PROPOSED RESIDENTIAL DEVELOPMENT: DITTON EDGE (APP RE: TM/18/02966/OA)

TRANSPORT ASSESSMENT ADDENDUM

REPORT REF. 182600-19A PROJECT NO. 182600 JANUARY 2020

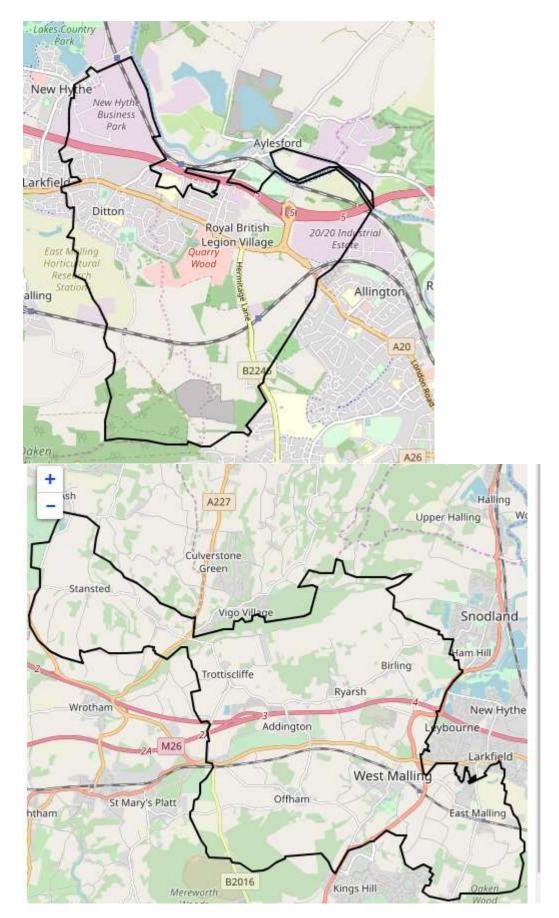
The modal split has been calculated using census data and this is acceptable but please clarify area 014. Areas 005 and 014 are shown in the maps below – Site B is in 005 and Site C is in 014. Given the significant overlaps between the assessments for the two sites, and to ensure a consistent approach we have used average values across the two sites for modal splits and growth.
